Proposed Increased Data Rate of RF Watermark Modulation in A/110

In ATSC A/110, an RF watermark was specified for transmitter identification and channel impulse response measurements in a single-frequency network environment. A/110 also provided for the modulation of the RF watermark, enabling its use for data transmission, radio location finding, and a variety of other applications. The RF watermark consists of four consecutive binary sequences (16-bit Kasami sequences – together termed the TxID sequence), the total length of which equals the ATSC field length; see Figure 1(a). The modulation of the RF watermark specified in A/110 is phase modulation of an entire TxID sequence, synchronized to the 8-VSB data fields, resulting in transmission of 1 bit of data per ATSC field and yielding a data rate of 41.3 bits/sec.

Figure 1. (a) A/110 RF watermark data transmission system (1 bit per 8-VSB field); (b) Proposed data transmission system with 4 bits per 8-VSB field; (c) Proposed data transmission system with 2 bits per 8-VSB field.

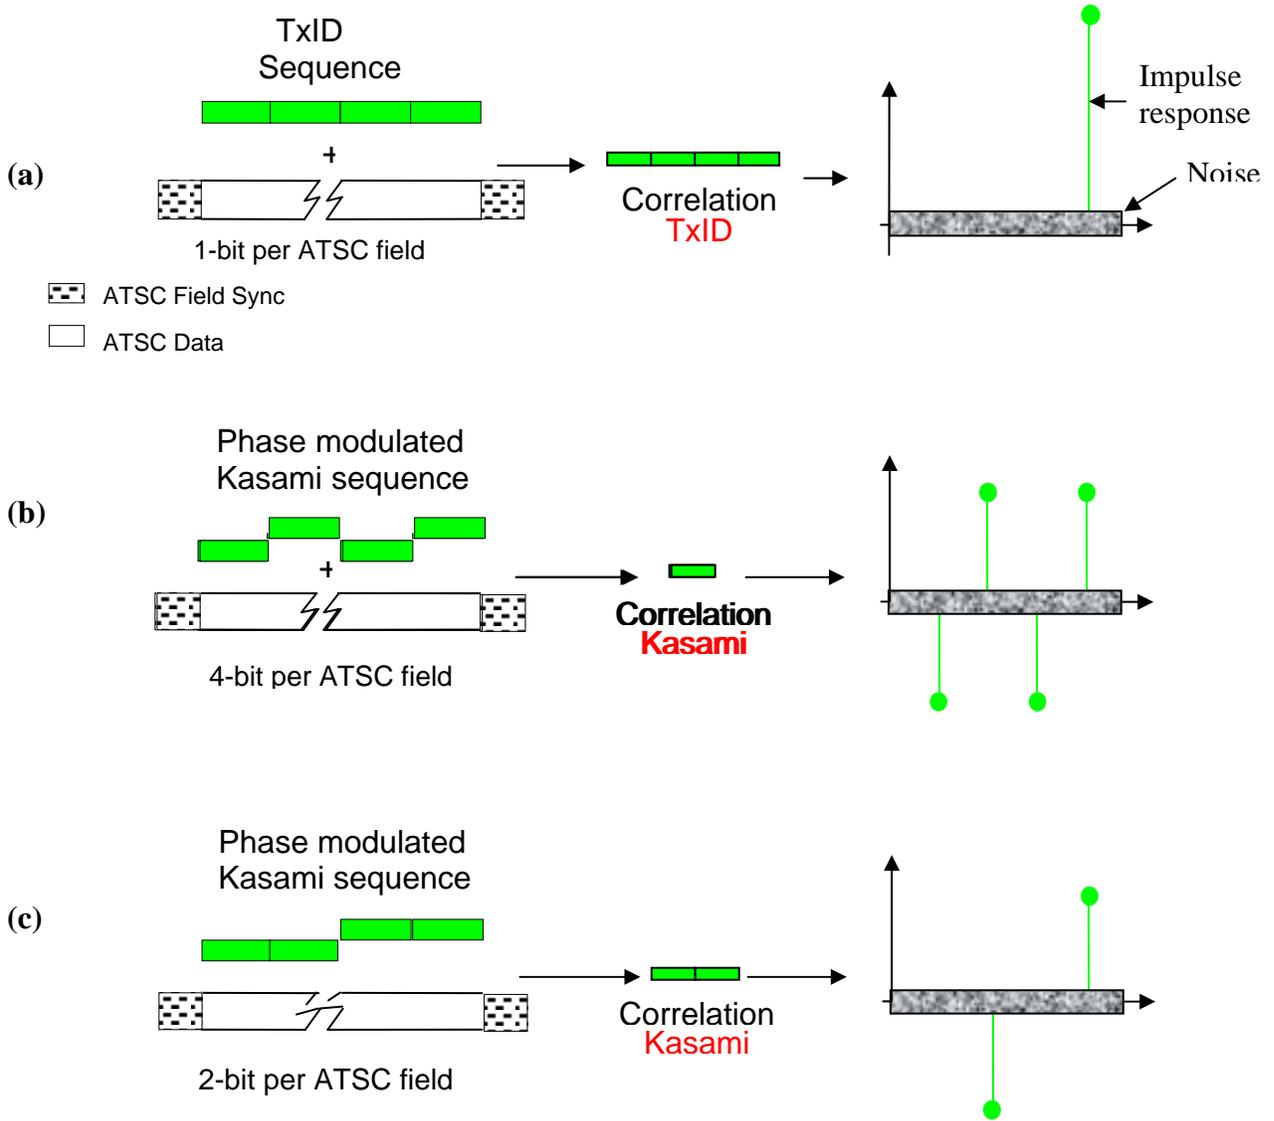
The proposed modulation parameters would allow phase alternation of each 16-bit Kasami sequence, as shown in Figure 1(b), rather than of the entire TxID sequence. Since each TxID sequence consists of four 16-bit Kasami sequences, the data rate for the proposal is four times that of the existing standard, i.e., 165.2 bits/sec.

Another option is phase modulation of two Kasami sequences together, as shown in Figure 1(c). This choice would result in a data rate of $2 \times 41.3 = 82.6$ bits/sec, or 2 bits per ATSC field. The corresponding BER performance, as shown in the middle curve of Figure 2, is 3 dB more robust than the 4-bits per field approach, and 3 dB less robust than the existing standard.

sequence, any of the three modes can be obtained through proper coding of the data. To enable the widest range of applications of the data carried on the RF watermark, no constraint should be applied in A/110 to the data formatting. Consequently, subsections that previously provided a very limited scheme for data coding and formatting are proposed to be removed, with no substitution made.

Figure 2. BER performance vs. watermark injection level for different watermark data transmission systems

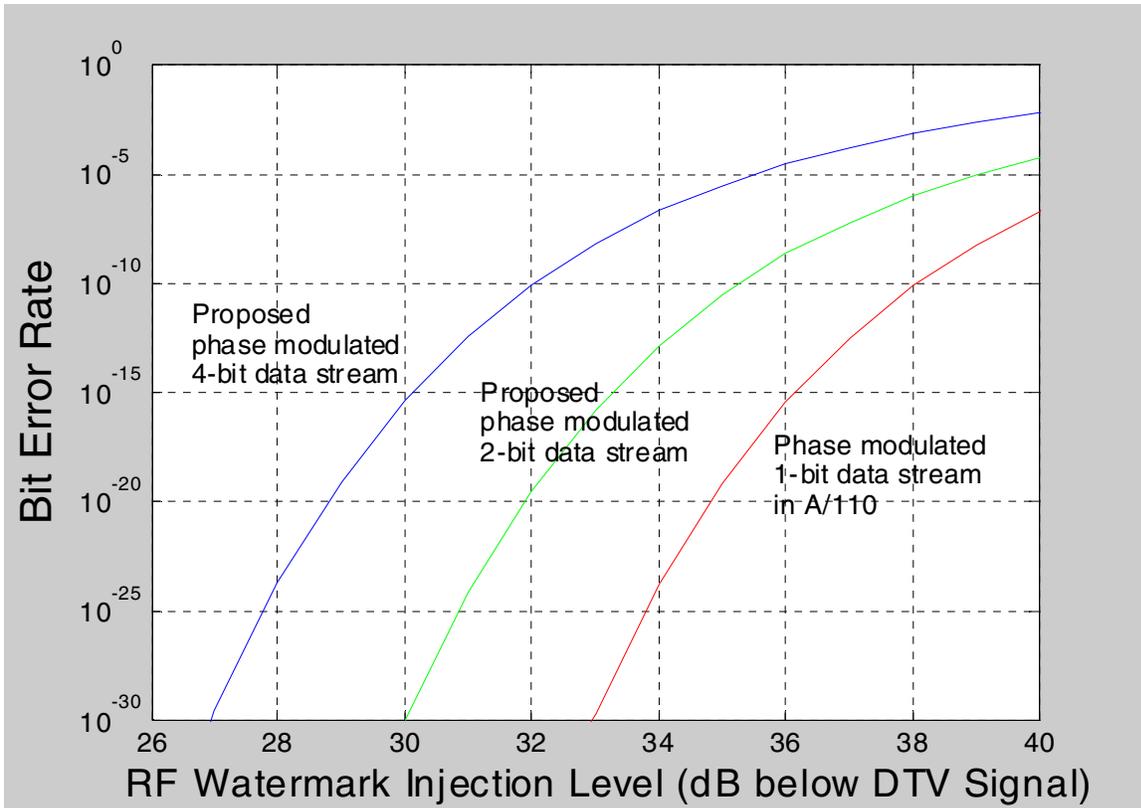
The BER performance of the existing A/110 watermark data transmission is presented in the right curve of Figure 2. One can see that the BER curve is VERY robust. For a watermark injection level 36 dB below the DTV signal, which has absolutely no impact on DTV reception, the BER is 1E-15. This means 769,000 years per transmission error! The proposed amendment to A/110 would relax the watermark data robustness by a small amount in exchange for a higher data rate.

The BER performance of the proposed system is shown in the leftmost curve in Figure 2. At a watermark injection level 33 dB below the DTV signal (again, having no impact to DTV reception), the BER is still 1E-8, or 7 days per error.

As shown in Figure 2, three different modes of data transmission are possible, with different data rates and robustness. By permitting selection of the RF watermark phase independently for each Kasami
